THE CORPORATION OF THE CITY OF VERNON

MATTERS REFERRED

RE: Development Variance Permit Application #00499 for Lot 27, Plan KAS1975, District Lot 6, ODYD (156 Sunset Boulevard) ("156 Sunset")

<p>WILLERTON ENGINEERING 4408 28 Street Vernon, BC V1T 7P5 250-542-5434</p>	Project Name:	Blaeser Residence	Job Ref.	20-287
	Section	Structural Assessment	Sheet no.	Page 1 of 4
				Date

Figure 1: WE site measurements of the retaining wall

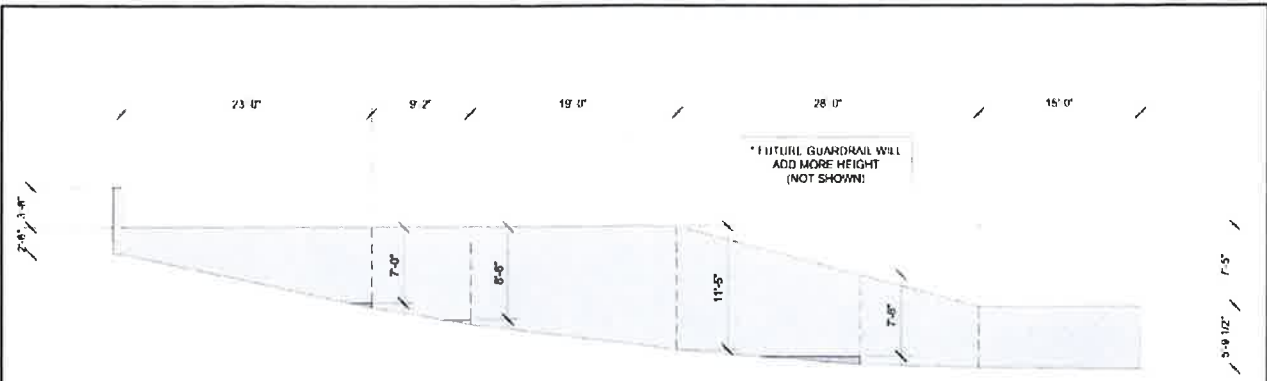
At the site visit, WE took measurements along the wall length for comparison. Refer to Figure 1. All length measurements are estimated to be within a foot of accuracy. All height measurements are estimated to be within two inches of accuracy. A panoramic photo of the retaining wall for comparison has been included. Refer to Figure 2.

Figure 3: Section B

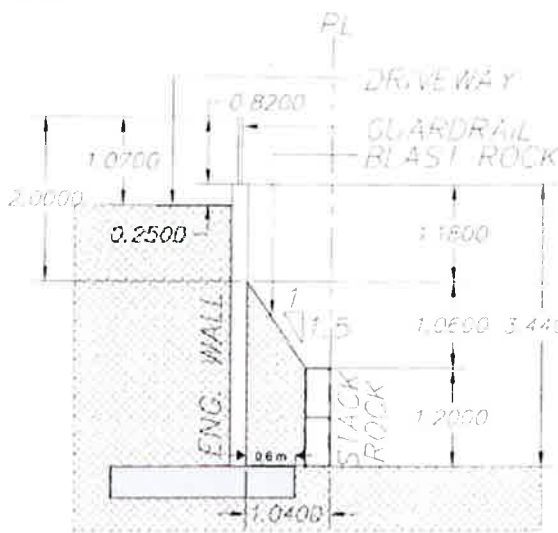
When compared to the 5 cross sections in the DVP application, it appears the surveyed heights are measured from the top of footing to the top of wall. WE has taken a copy of Sections B, C and D from the DVP application and added a 24" wide toe/footing and soil hatching to the cross section. The heel length and footing depth are unknown to WE and generically illustrated. Refer to Figures 3, 4 and 5.

Traditionally, a cantilevered concrete retaining wall footing would be installed below frost depth, unless a geotechnical engineer verified the footing was located on non-frost susceptible material. Additionally, burying the footing helps to stop the wall from sliding.

The proposed solutions illustrated in Sections B, C and D may not be structurally suitable to restrain the installed retaining wall from sliding if the wall was not designed with a shear key or alternate form of lateral restraint. The design engineer for the retaining wall should be given the opportunity to review and confirm that the proposed solution structurally meets requirements for sliding and frost protection.
